RE: Response to Technical Evaluation Comments and Information Request of CES's Responses to EPA's Initial Technical Evaluation Comments and Information Requests #1-4 CES-Mendota Site Underground Injection Control (UIC) Permit Application Class VI Pre-Construction Permit Application No. R9UIC-CA6-FY20-1

### Evaluation of Applicant Responses to EPA’s Technical Review Comments on the Geologic Information in the CES-Mendota Class VI Permit Application

Figure 2c and 2d: San Joaquin basin depositional model showing three possible depositional scenarios for the location of Mendota\_INJ\_1. Modified from (Hosford Scheirer & Magoon, 2007)

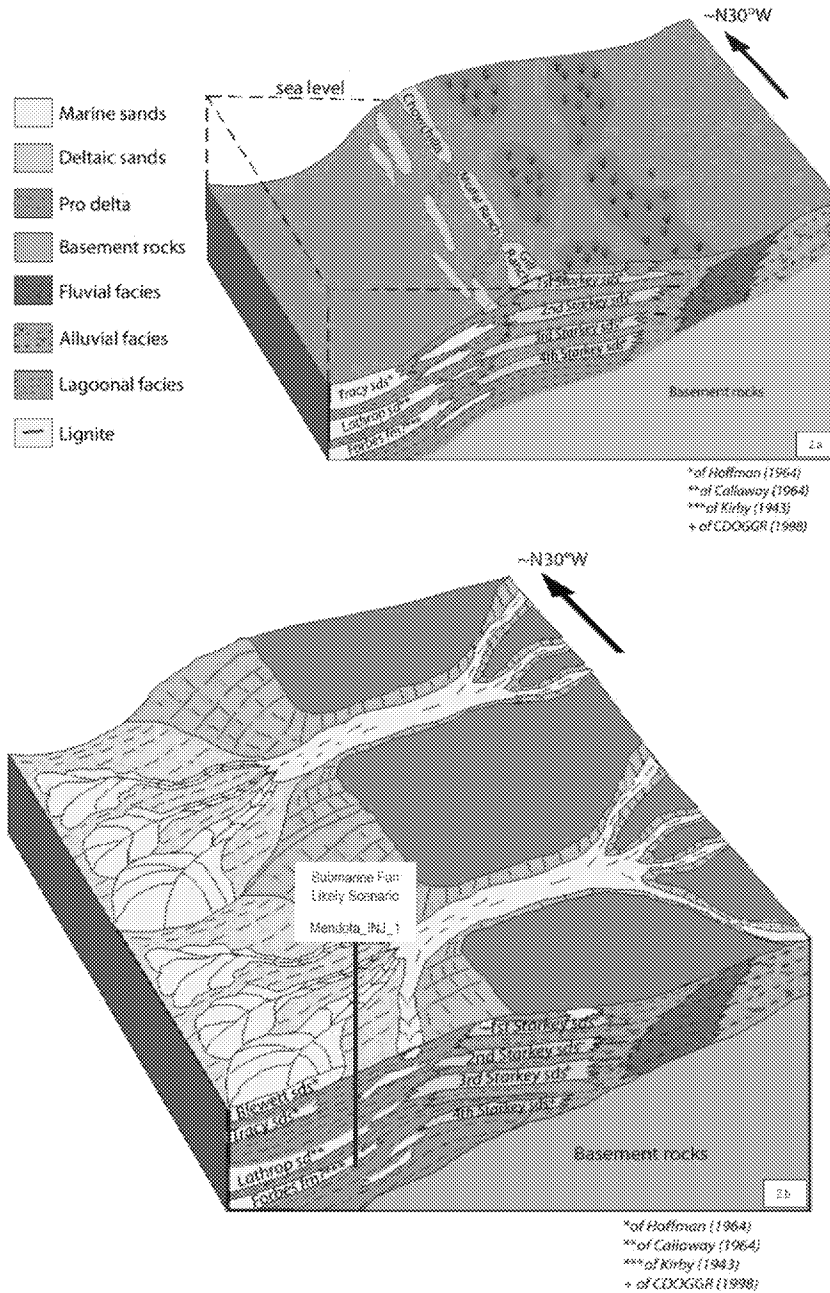
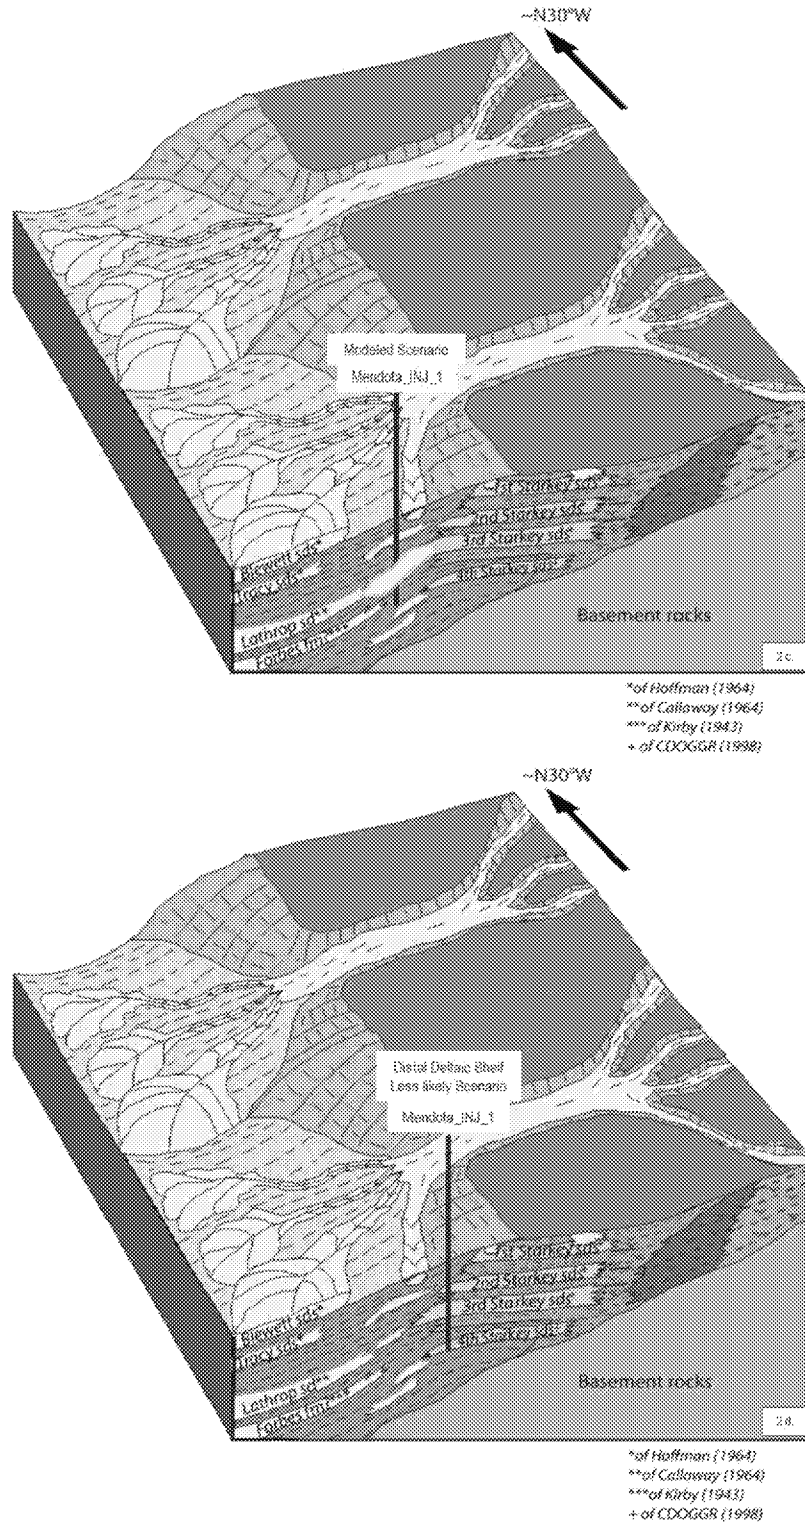
- The Mendota\_INJ\_1 well location in Figures 2a–2d is supposed to be the same location. The series of diagrams intends to demonstrate the possible depositional environments that Mendota\_INJ\_1 could encounter. It is also intended to show that a conservative model (one in which all sands are modeled as one flow unit, posing the greatest leakage risk, Figure 2c was pursued for preliminary site characterization due to lack of site-specific data.

- Is the 2nd Starkey the same as the 2nd Panoche? If so, then is it coeval with the Tracy sands? The diagram in Figure 2c (modeled scenario) shows the well penetrating the level of the 3rd Starkey. In the “likely scenario” in Figure 2b, it appears that the well goes as far down as the level of what might be the 4th Panoche sand. Although the 3rd and 4th Panoche sands are potential injection scenarios, should the diagrams in Figures 2a-2d represent the planned injection into the second Panoche?

The following text will be added to the Regional Geology section of the revised narrative attachment to add clarification regarding stratigraphy of the proposed storage complex. This summary should clarify the stratigraphic description and adequately answer questions posed.

Figure 3: Porosity-permeability crossplot model cells colored by formation (from Petrel 2019).

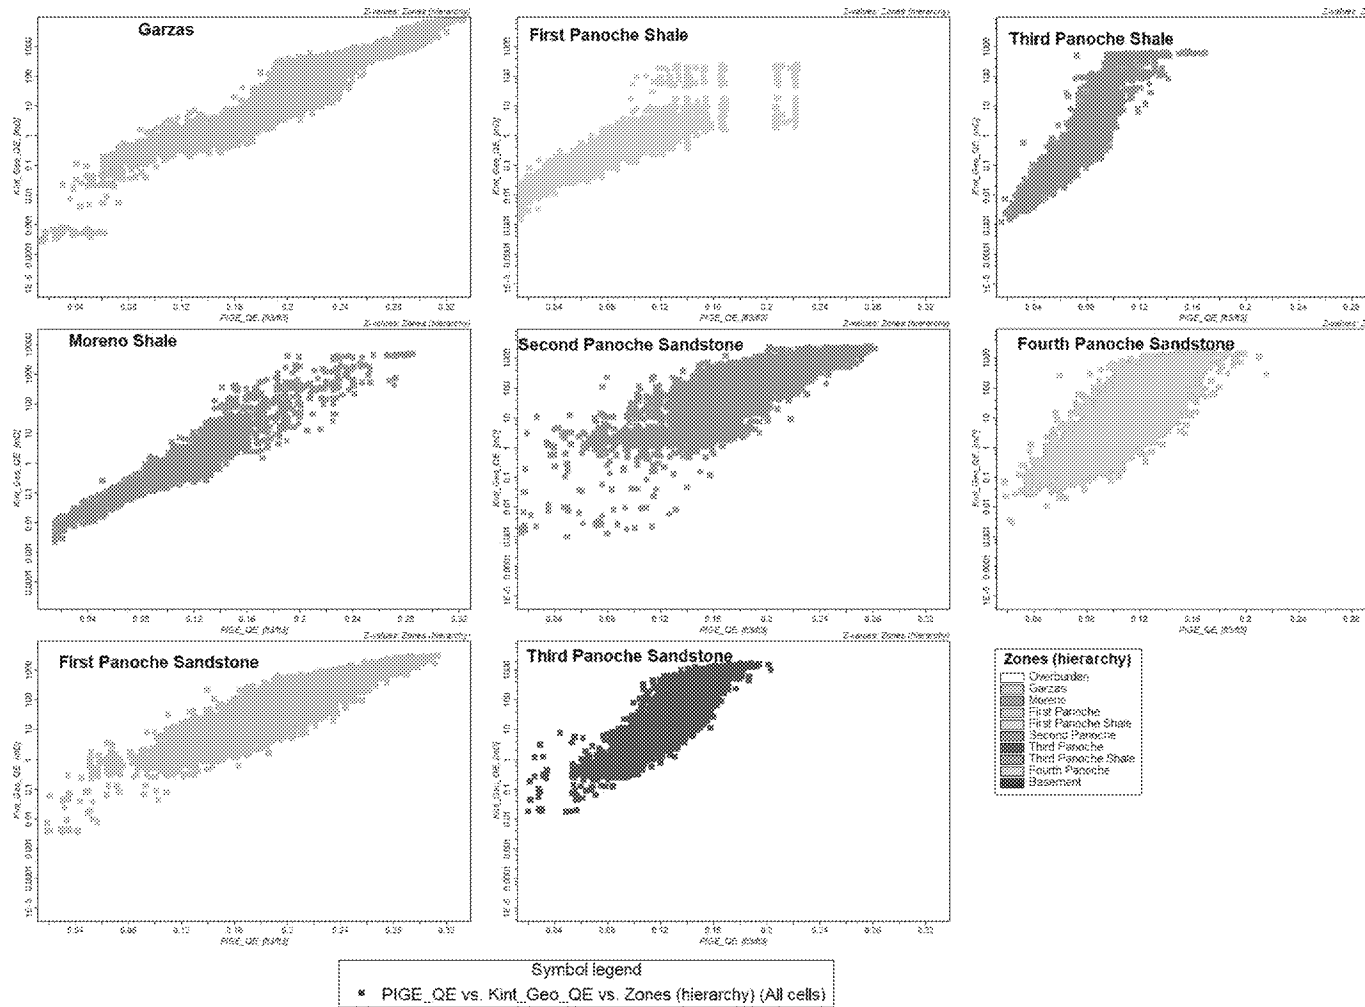
The graph in Figure 30 of the narrative showing porosity vs. permeability by formation is labeled as Z values and the legend title is “Zones.”

- Please clarify the meaning of the zones in the legend of Figure 30. Are they equivalent to the formations, as suggested by the legend?
  - *Zones are equivalent to formations. For clarity, Figure 30 has been updated and divided into Figure 3, Figure 4, and Figure 5 in Appendix A.*

- Were the graphs in Figure 30 the basis for assigning phi and k in the layering in the model domain?
- *For clarity, Figure 30 has been updated and divided into Figure 3, Figure 4, and Figure 5 in Appendix A. The graphs show the unique porosity/permeability relationships per zone. The corresponding variables were used in the layering model.*

Figure 4: Porosity-permeability crossplots of well logs and upscaled cells (from Petrel 2019).

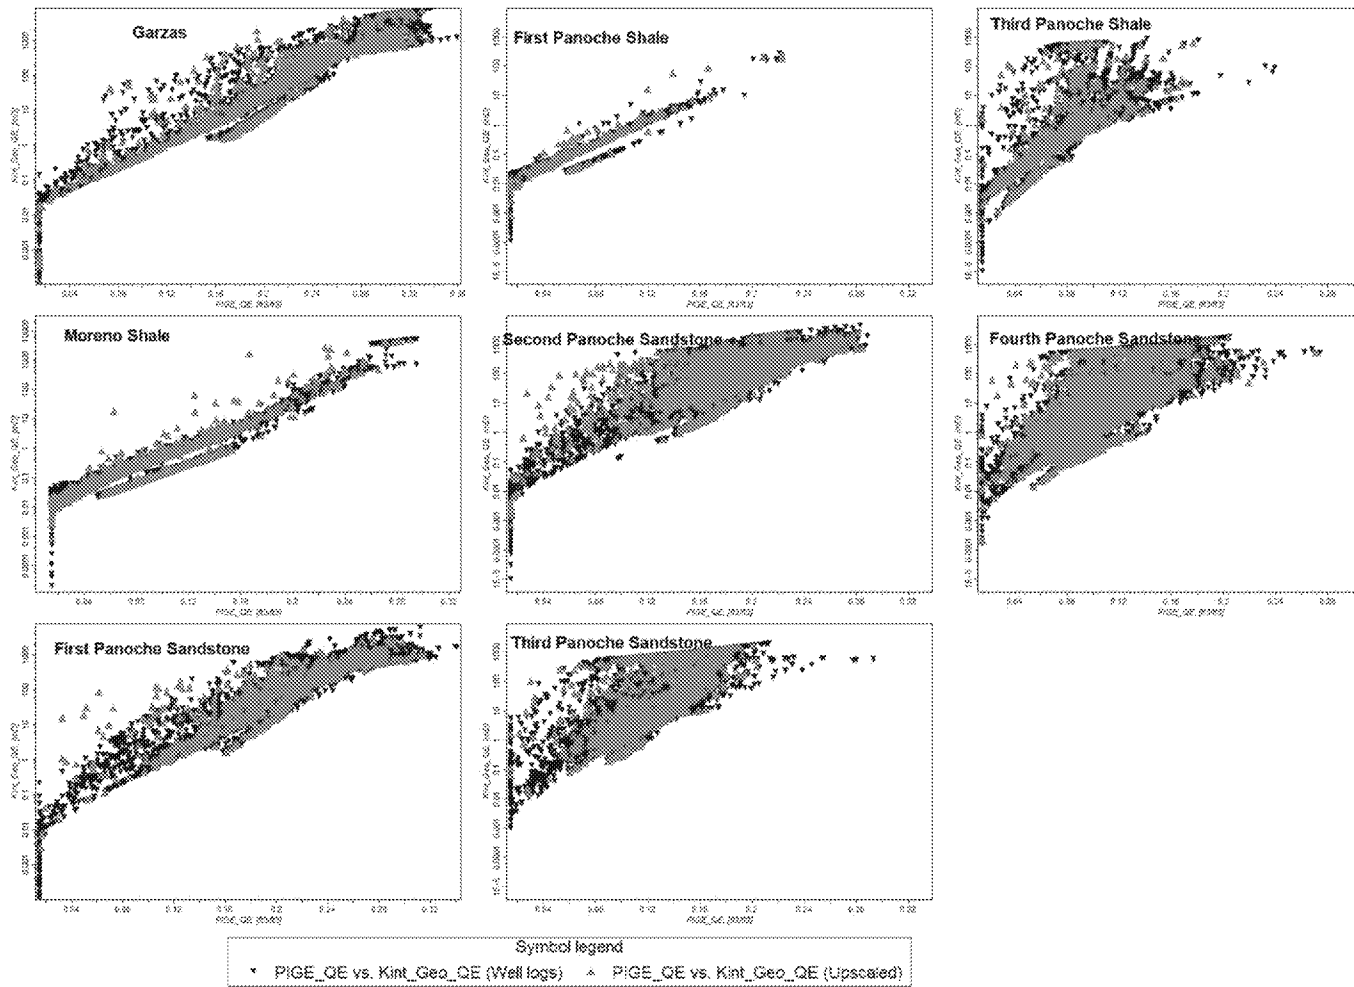
- In the plot of well log-derived data points, upscaled values, and full-field simulated cells, the upscaled values dominate. It appears that the upscaled value symbols may have been layered over the other symbols. Please revise the figure to show the distributions of all three types of data points more clearly.
  - *For clarity, Figure 30 has been subdivided into three figures. Please refer to Figure 3, Figure 4, and Figure 5 in Appendix A.*

Figure 5: Porosity-permeability crossplots of well logs vs. facies type (sand and shale) (from Petrel 2019).

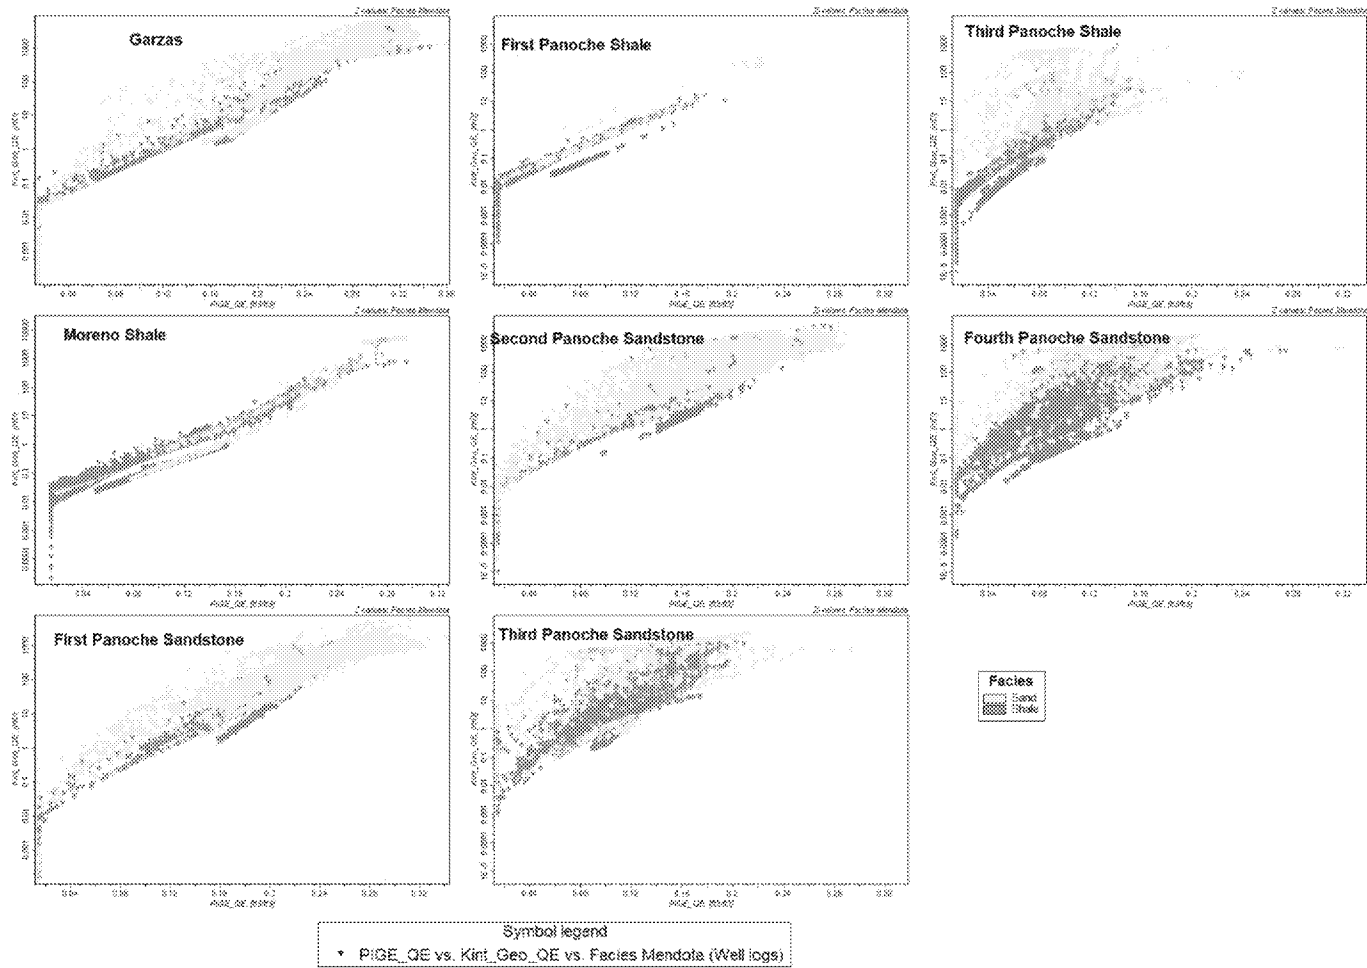
In comparing Figure 1 in the Rock Type file with Figure 30 of the narrative, the facies in Figure 30 show a broad spread rather than the sharp dividing line in Figure 1. It appears that a number of shale data points in Figure 30 were assigned to the sandstone facies by the neural network training method in Figure 1. There also appears to be a significant difference in porosity between the Fourth Panoche and the Second Panoche Sands in Figure 30.

- Why was the information shown in Figure 30 of the narrative not used as the basis for assigning these curves?
- *The facies model described in Figure 30 (updated with Figure 5) was a preliminary estimate to perform fault seal analysis. This facies log was not used as part of the petrophysical model interpolation. The rock classification methodology (neural network) was used to create the hydrofacies interpretation needed for dynamic modeling. Porosity and permeability of the geocellular model were upscaled to a larian grid used for dynamic modeling. Please refer to Figure 6 in Appendix A.*

- Please discuss how these two methods of assigning facies were used to inform the geomodel and, consequently, the numerical model.
  - *The facies model described in Figure 30 (updated with Figure 5) was only constructed to characterize fault seal analysis; it was not used to inform the geomodel. The rock typing methodology with neural network was applied for the classification of hydrofacies (rock types) to assign relative permeability and capillary pressure functions in the dynamic modeling.*

- *The rock types presented in Figure 30 of the narrative, which are updated in Figure 5, were used for fault seal analysis. The petrophysical property interpolations were completed on a zone-by-zone basis and did not use these facies types in the petrophysical modeling. For example, the unique petrophysical properties (Figure 3) for the Fourth Panoche Sand are accounted for in zone-specific petrophysical modeling. After well log data are acquired, the rock typing will be calculated using a more advanced methodology such as HRA. Likely, this analysis will focus on three to five different rock types, thus enabling characterization of the Second Panoche Sand and other potential injection sands. Different shale classes will be informed by core mineralogy and digital log responses for various shale seals such as the First Panoche Shale (primary) and Moreno Shale (secondary).*

Figure 6. Rock types along the E-W cross section (from Petrel 2019).

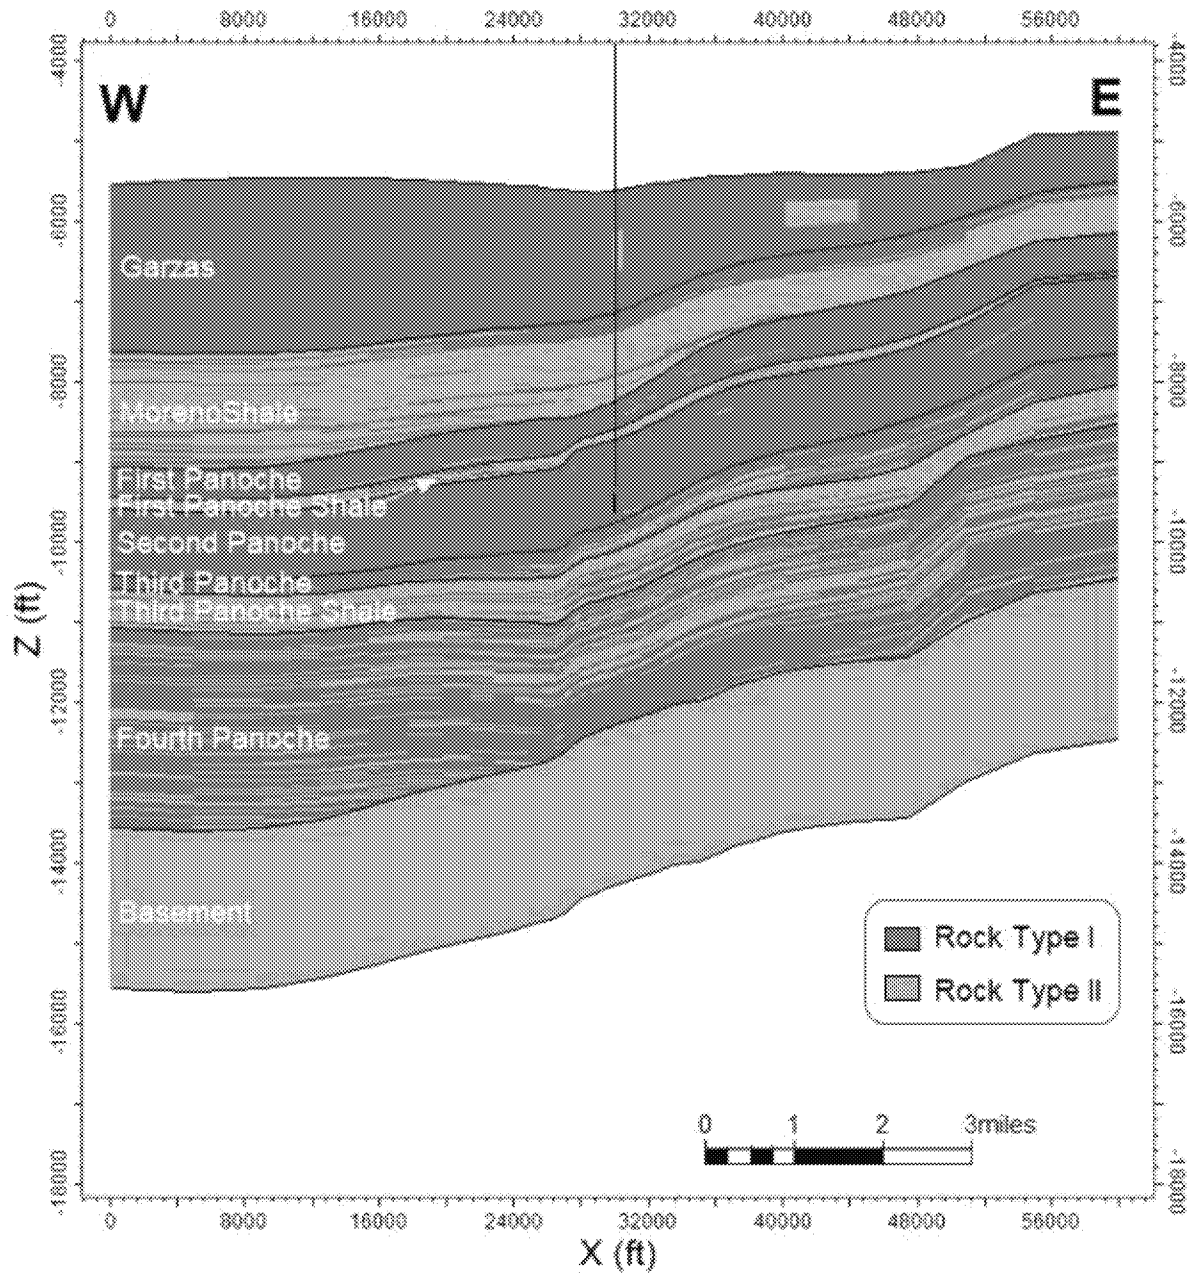
- Is there a difference between the two shades of blue in Figure 2 of the Rock Types file?
  - *No, the different blue shades are due to the presence of grid lines shown on the figure. Refer to Figure 6 in Appendix A for an updated version.*

- Please label the formations in Figure 2.
  - *Refer to Figure 6 for an updated version of Figure 2 in Appendix A which includes the formation names.*
